**CITY OF AUSTIN
APPLICATION TO BOARD OF ADJUSTMENT
GENERAL VARIANCE/PARKING VARIANCE**

CITY OF AUSTIN – PLANNING AND DEVELOPMENT REVIEW DEPARTMENT
SITE PLAN APPLICATION – MASTER COMMENT REPORT

CASE NUMBER: SP-2014-0226DS
REVISION #: 00
CASE MANAGER: Rosemary Avila

PROJECT NAME: 7900 Big View
LOCATION: 7900 BIG VIEW DR BLDG BD

SITE PLAN - W / EXISTING BOAT DOCK

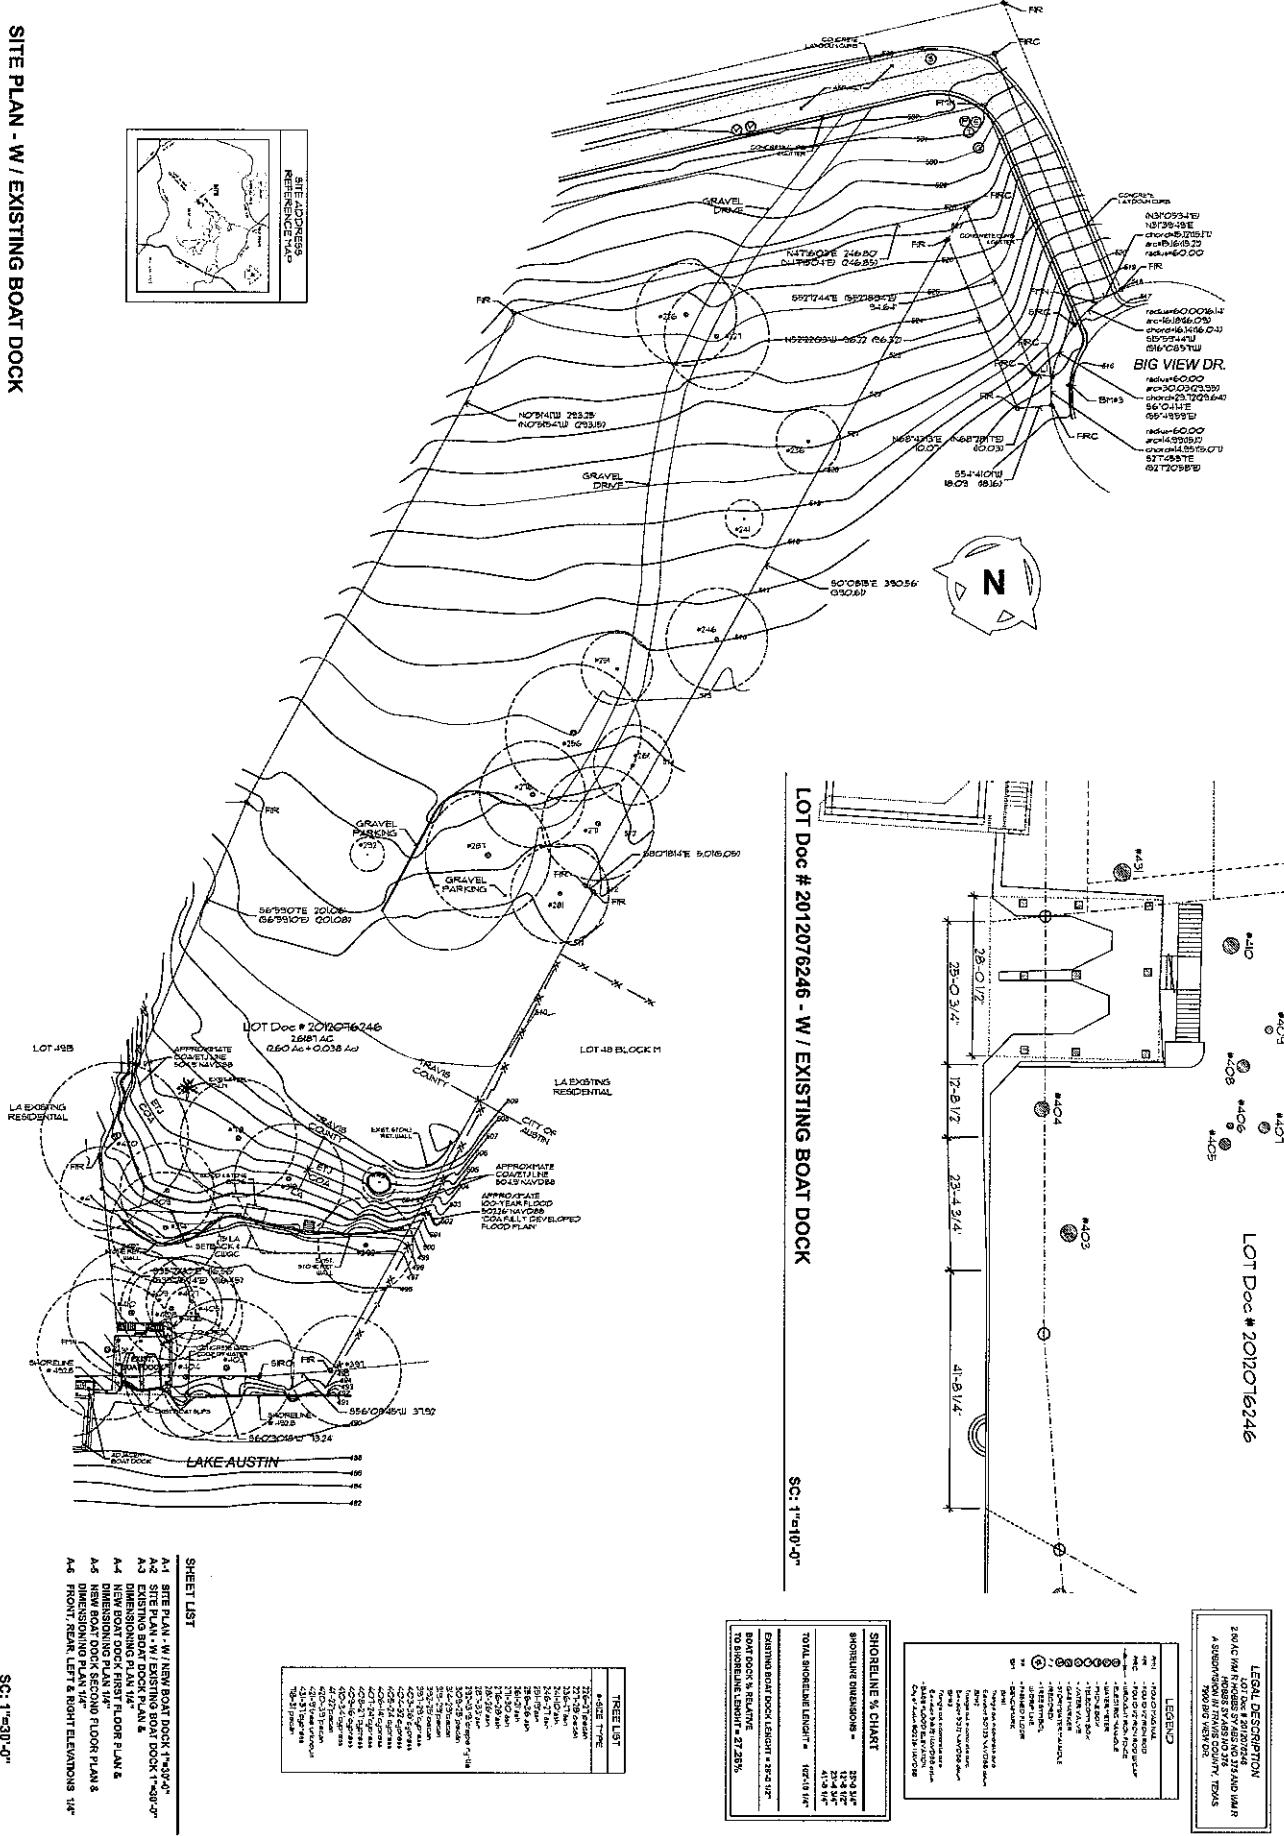
- SP1. Depict and label the lake gradient line on the site plan, showing the shoreline during the period when the lake is lowered. The Lake Austin gradient line normally follows the 482.0 ft. contour, and the proposed boat dock cannot extend past the gradient line. Please provide the topographical datum basis used for location of the gradient line.

- SP 2. Call out the Lake Austin shoreline elevation as 492.8.
- SP 3. Show the 75-foot shoreline setback on the plan, and include this note on the site plan sheet: "Permanent improvements are prohibited within the shoreline setback area, except for retaining walls, piers, wharves, boathouses, marinas or a driveway to access the structures [LDC 25-2-551(B)(2)]".

- SP 4. Demonstrate that the proposed width of the boat dock does not exceed twenty percent (20%) of the length of the shoreline [LDC 252-1176(D)(2)]. Any application for a dock that exceeds 20% will require Planning Commission approval.

- SP 9. Add note on the site plan indicating piling size.
- SP 10. For LA zoning the setback cannot exceed 10' [25-2-492].
- SP 11. On the site plan, show the zoning and land use of the adjacent properties.

EXISTING BOAT DOCK DIMENSIONING PLAN

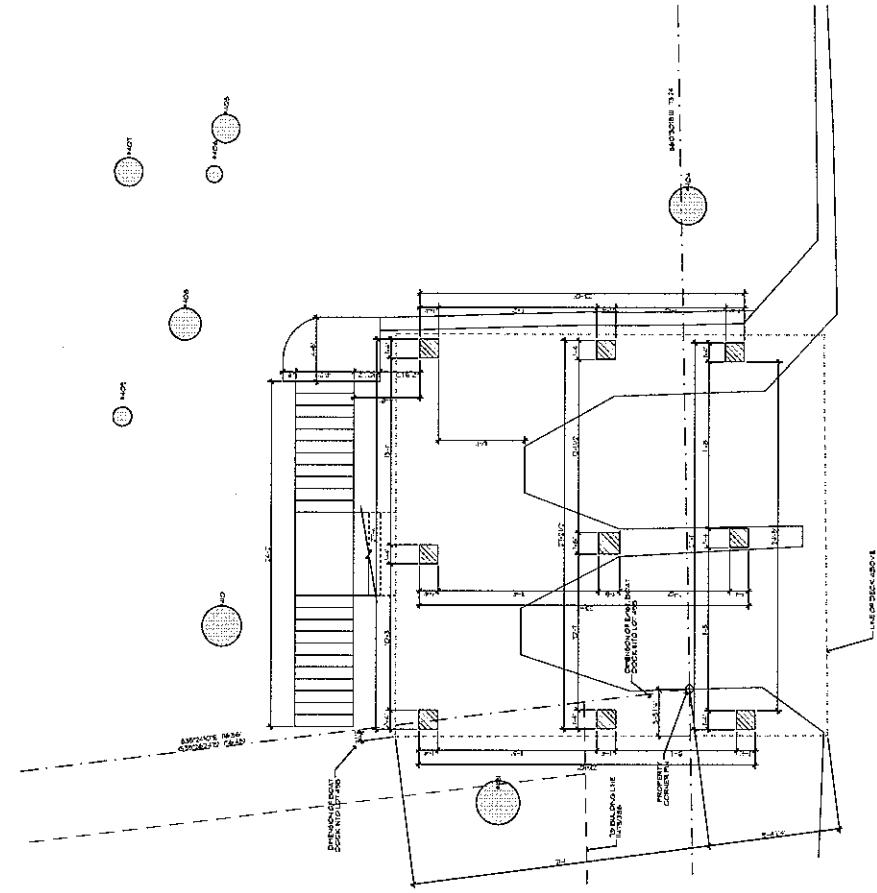
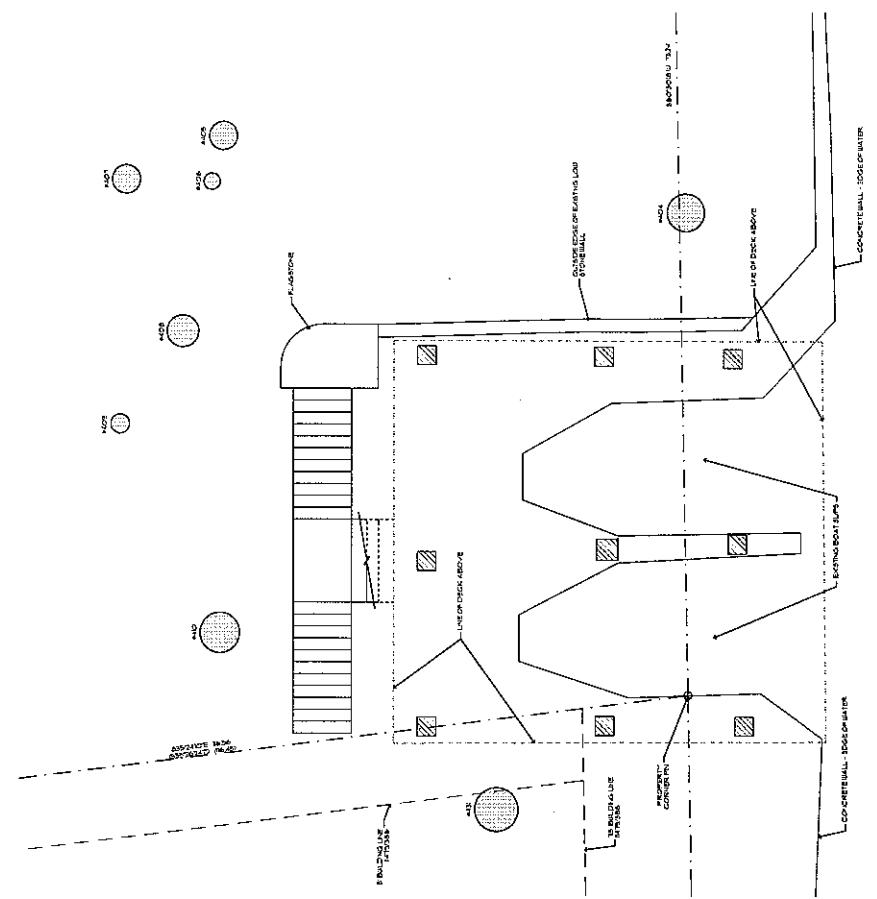
EV 12 It appears that a portion of the cut-in slip is proposed to be filled. Please clarify. Clearly delineate the existing 492.8 shoreline and the proposed location of the 492.8 shoreline on all relevant sheets. Additional comments may be generated.

FRONT ELEVATION - VIEW FROM STREET

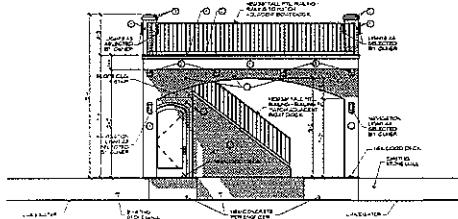
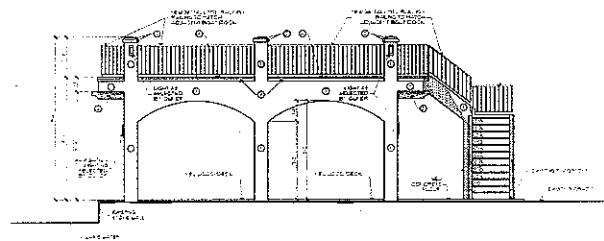
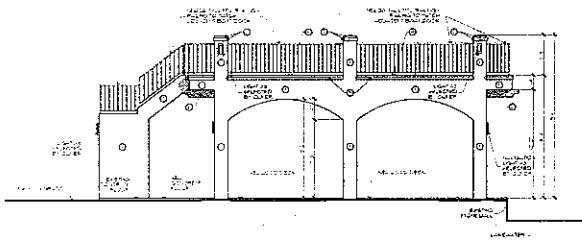
- SP 7. Label the dock dimensions (width and length) on page 7.
- SP 8. Will the boat dock be enclosed, and/or will any roof covering be provided? Structural plans have been provided with this submittal, but no architectural information and/or elevations – please include. Please add note the proposed dock will not be more than 30% enclosed.
